REMARKS

Studer Patent - First Office Action Response

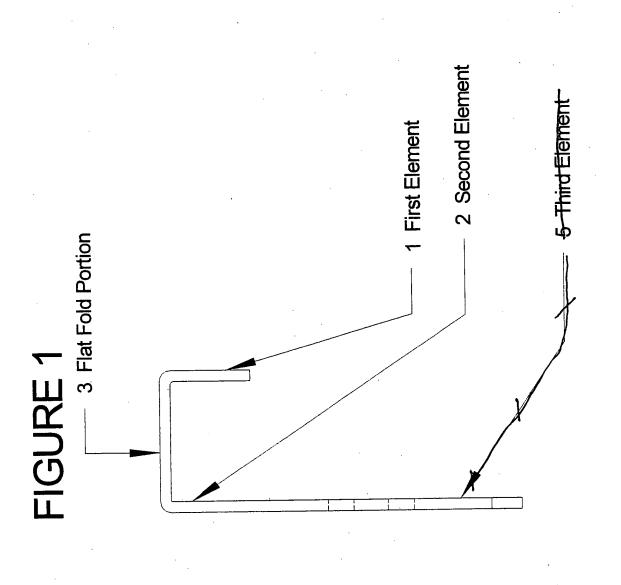
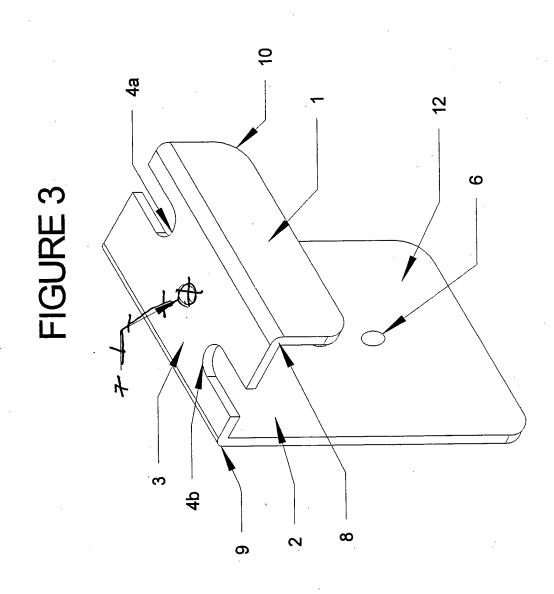
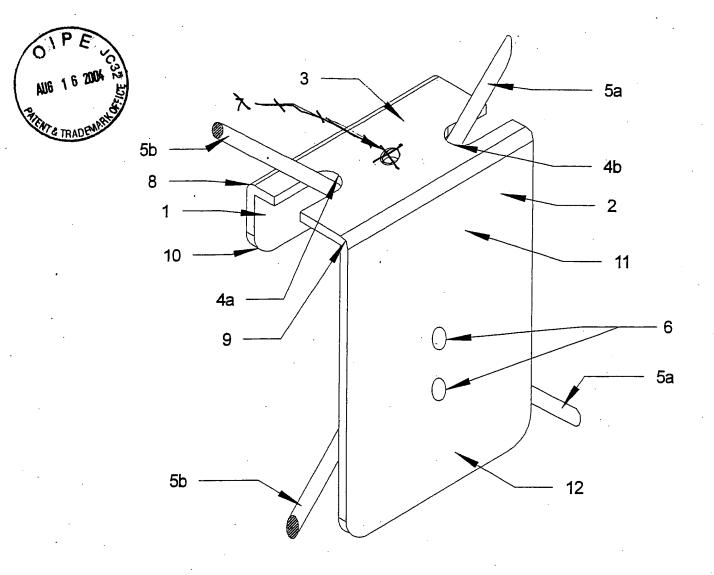
The drawing objections are noted and are corrected with new drawings submitted herewith.
